## **Spokane Park Board Agenda**

## Design-Build Change Order Form

Change Order Number: <b>3</b>	Change Order Effective Date: <b>5/11/18</b> (date when executed by both parties)
Project: <b>PAVILION DESIGN BUILD PROJECT</b>	Design-Builder's Project No:
	Date of Agreement: <b>APRIL 13, 2017</b>
Owner: <b>CITY OF SPOKANE - PARKS &amp; RECREATION DIVISION</b>	Design-Builder: <b>GARCO CONSTRUCTION, INC.</b>

**PAVILION DESIGN BUILD PROJECT**  
**Change Order #3**  
**Backup Documentation**

4 TYPE 1 WAYFINDING DEVICE FACE ELEVATION  
1" = 1'-0"

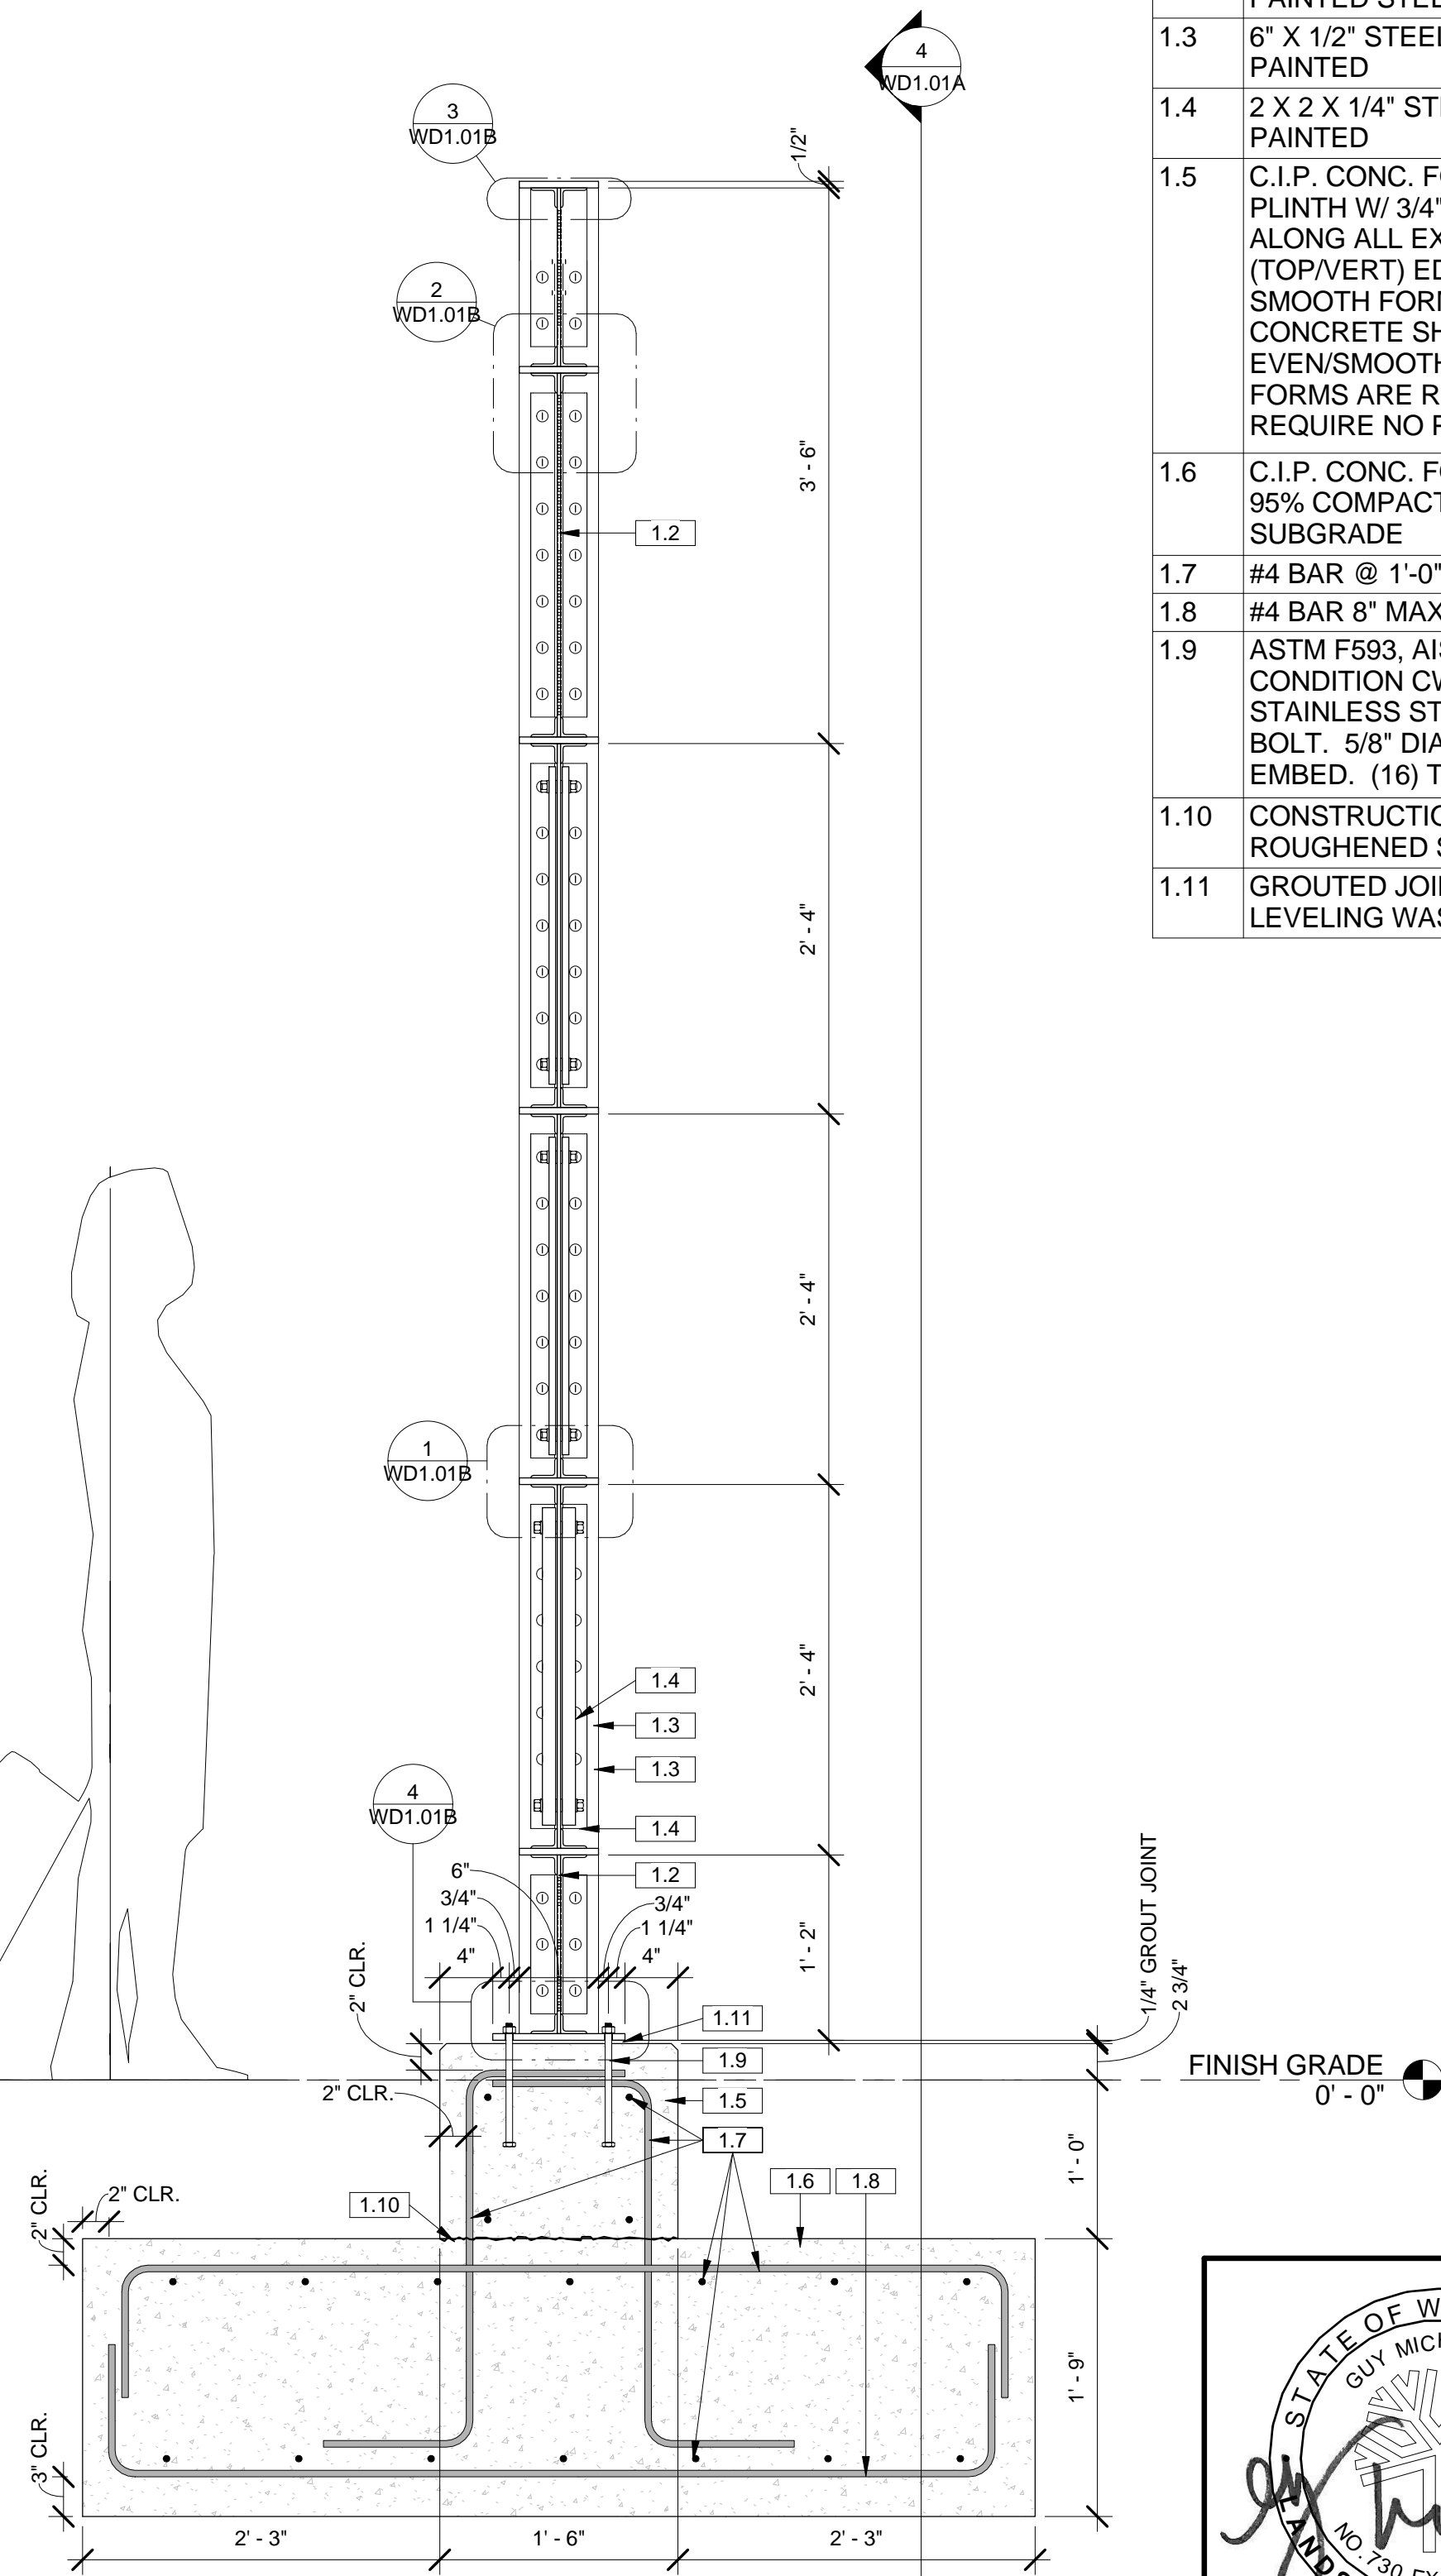
**Description:** Provide pricing to place the footings for the 13 signs as defined by the attached Wayfinding Master Plan, before the promenades finishes are installed. The requirements for the sign types and required footings are shown on the attached detail drawings from the South Bank Wayfinding package. The signage and graphics part of the sign will be issued as a change at a later date.
